ISSUE: Certificate of Appropriateness for alterations

APPLICANT: Ildar Abdullin & Anna Kachalova

LOCATION: Parker-Gray District
1310 Queen Street

STAFF RECOMMENDATION

Figure 2: Left: Approved rear elevation. Right: Proposed rear elevation with chimneys

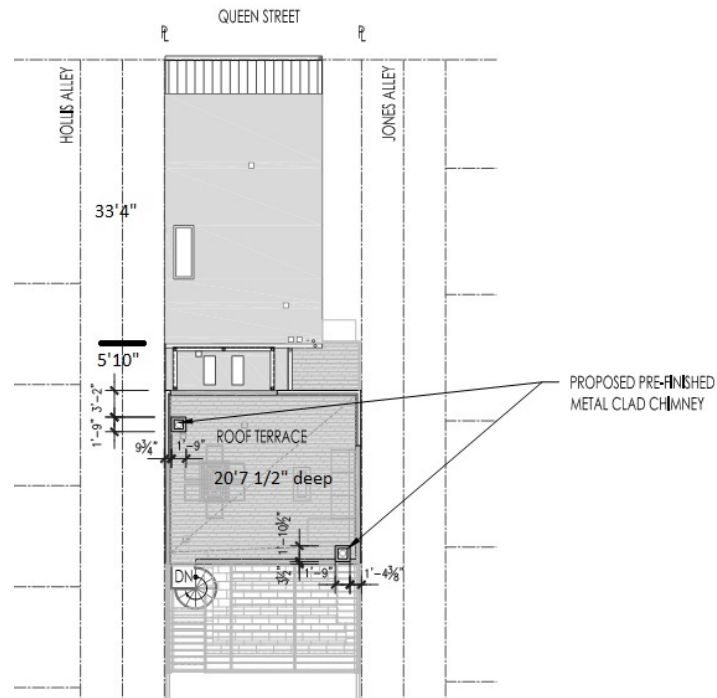
While the 10'-2 ½" height of the chimneys may sound tall, the stacks must be tall enough to carry smoke away from the roof deck. As the Board and staff know, Alexandria has numerous tall chimneys scattered throughout the town. To this point, the applicant included several photos in the application. While the proposed chimneys would be visible from the rear/south elevation (Figure 2) and the adjacent alleys, they would be minimally visible from Queen Street. The chimney on the west side of the house sits approximately 42' from the Queen Street/north elevation. The chimney on the east side of the house sits approximately 57' from the Queen Street elevation (Figure 3). Both chimneys are further obscured by the mansard roof on the north elevation (Figures 4 & 5) and the 3' parapet surrounding the roof terrace

Staff recommends approval of the project as submitted.
